Response to
Dated
12/16/25

ENGINE IDLE & FUEL VAPOR IN CESSNA 172R / 172S

A Historical Compilation of Service Publications

January 12, 2026

Figure 3. Fuel Return to Reservoir Installation (Sheet 1)

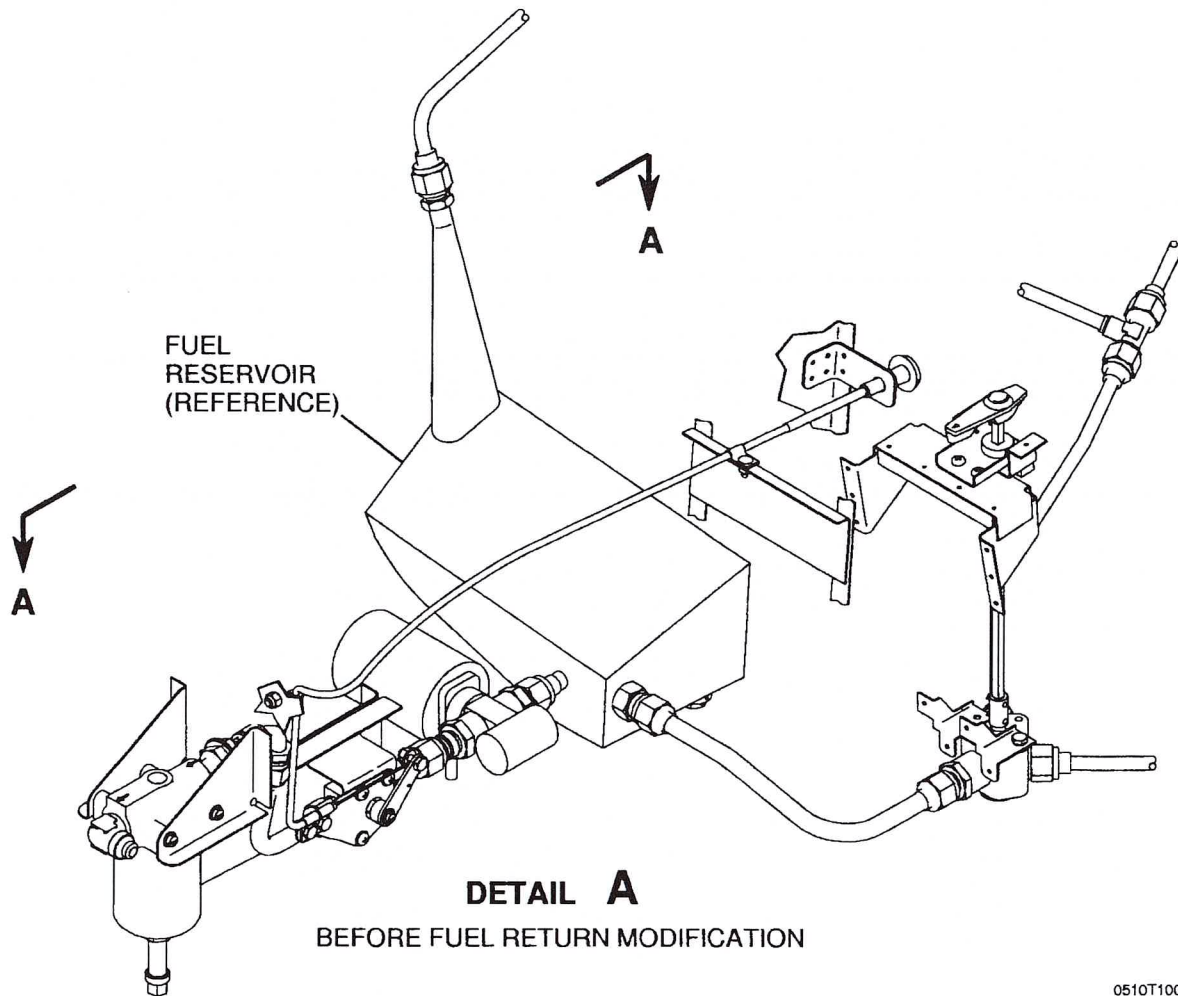
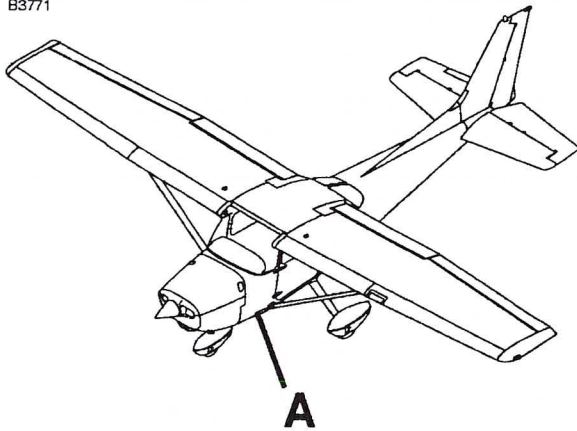
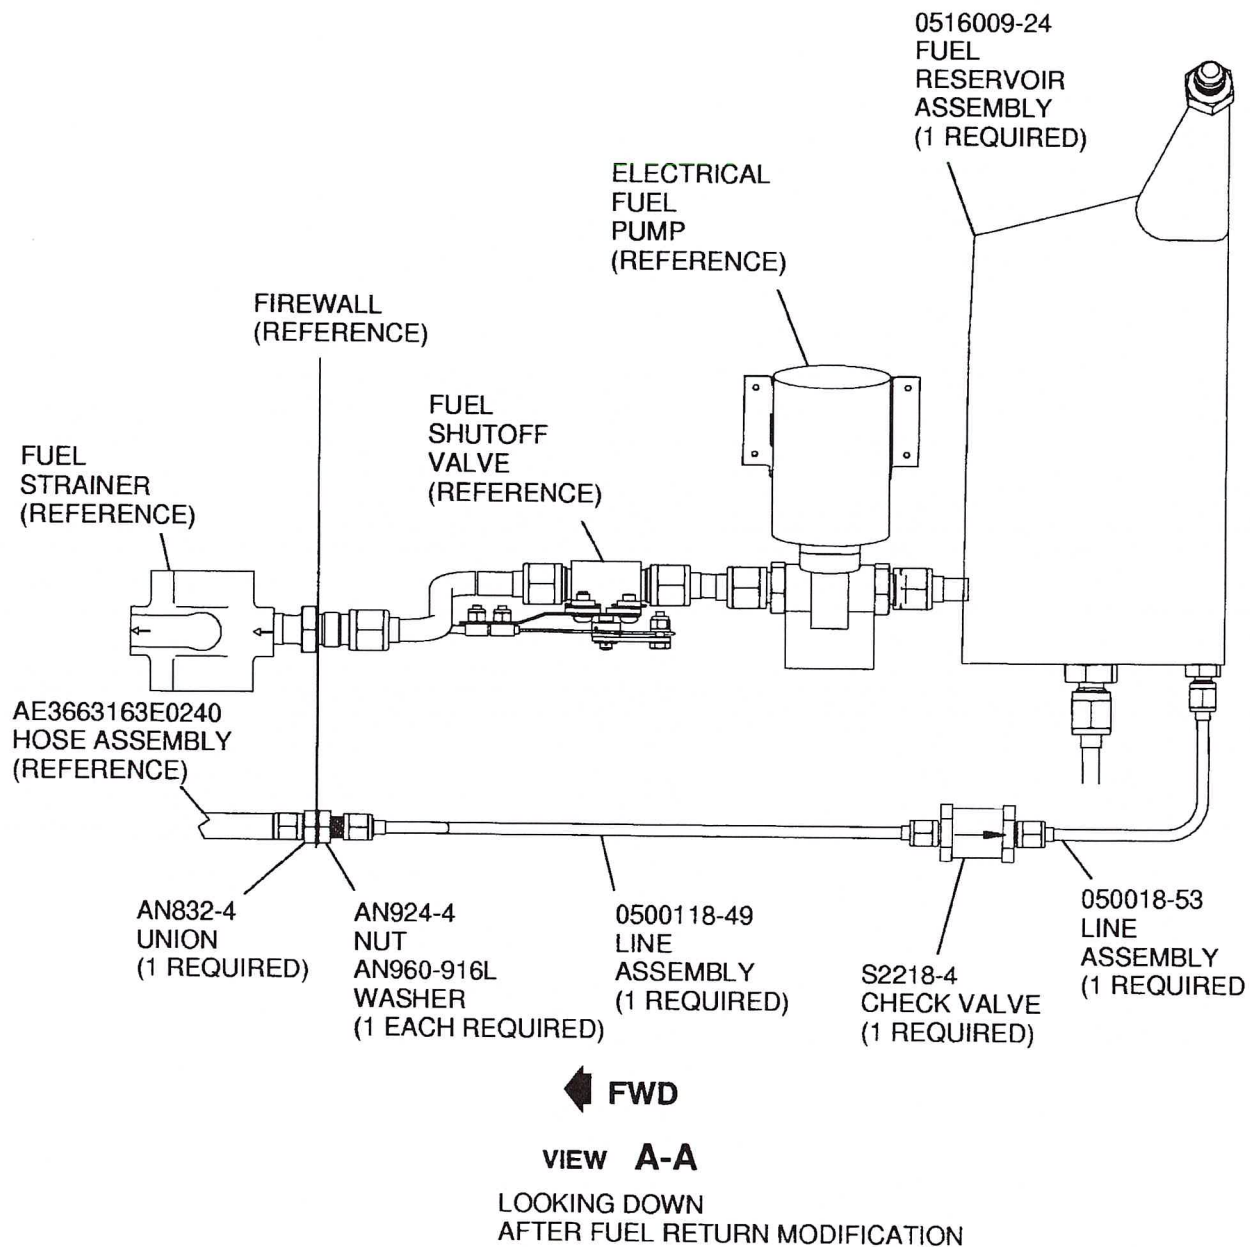
NOTE: The AE3663163E0240 Hose Assembly must be in a relaxed and smooth position before the nuts are tightened.
 - B. Install the other end of the AE3663163E0240 Hose Assembly nut to the firewall AN832-4 Union. Leave the nut loose until the hose is positioned and clamped to the brace as shown.
 - C. Attach the AE3663163E0240 Hose Assembly to the 0750625-4 Brace with clamps and hardware as shown.
 - D. Tighten the AE3663163E0240 Hose Assembly nuts but make sure it is in a relaxed and smooth condition after the nuts are tightened.
11. (Refer to Figure 3, Sheet 1.) Install the 0500118-49 Line Assembly from the aft side of the firewall AN832-4 Union to the S2218-4 Check Valve. Install the S2218-4 Check Valve and make sure the check valve flow arrow points to the reservoir.

12. Remove the 0516009-18 Fuel Reservoir Assembly that is installed in the airplane, keep all hardware. (Refer to the Model 172 Series 1996 and On Maintenance Manual, Chapter 28, Storage and Distribution-Maintenance Practices.)
13. Install a new 0516009-24 Fuel Reservoir Assembly into the airplane with the kept hardware.

14. Install a new 0500118-53 Line Assembly from the aft end of the S2218-4 Check Valve to the new 0516009-24 Fuel Reservoir Assembly. (Refer to the Model 172 Series 1996 and On Maintenance Manual, Chapter 28, Storage and Distribution- Maintenance Practices.)
15. Fuel the airplane and do a fuel leak inspection.
16. Install the floorboards and the side panels removed in Step 6.

Figure 1.

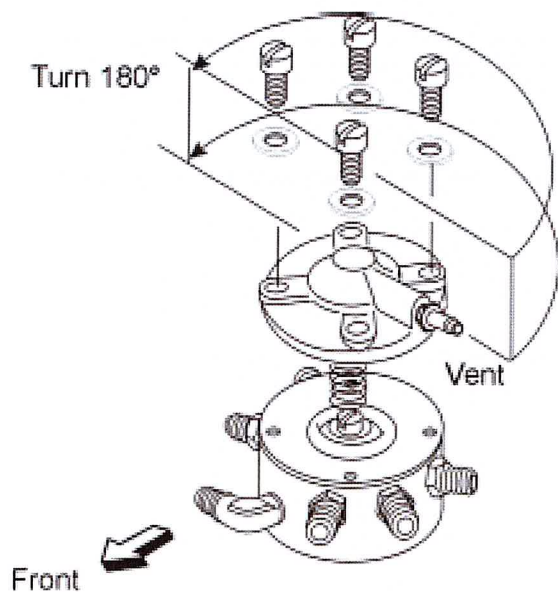
- a. Remove the lockwire, screws and washers from the top of the flow divider assembly. (Figure 1.)
- b. With the cap vent pointing left, slightly lift the manifold cap, making sure that it is separated from the diaphragm. Then carefully rotate it until cap vent points right. (180° from original position.) (Figure 1.) Be sure that the spring held in place by the cap is not dislodged.

Figure 2.

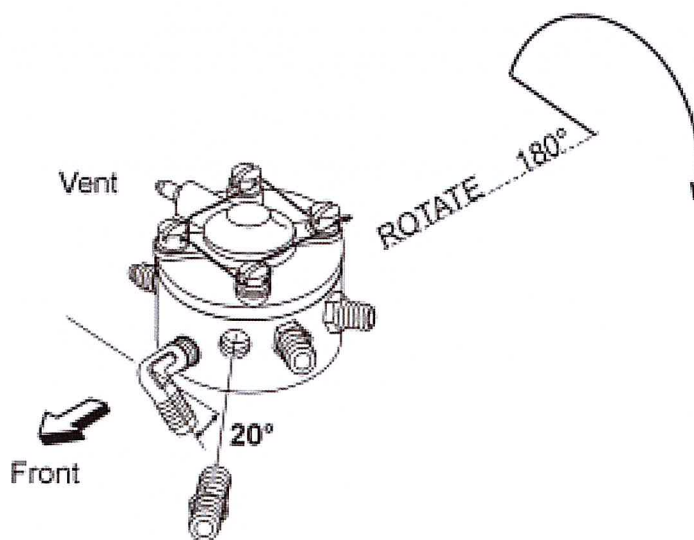
- d. To allow removal and installation of the 90° fuel inlet elbow, first remove the fuel gage fitting close to the elbow on the forward side of the flow divider. (Figure 2.)

- e. Holding the flow divider with the manifold cap up, remove the 90° elbow P/N MS20822-4 and install the new 90° elbow with the elbow positioned below the gage fitting port pointed left and tilted approximately 20° below horizontal. Reinstall gage nipple. The angle allows clearance for hose connections. Before reinstalling the fittings, apply Loctite Hydraulic Sealant or an equivalent fuel soluble sealant sparingly. Do not apply sealant to the first two lead threads. (Figure 2.)
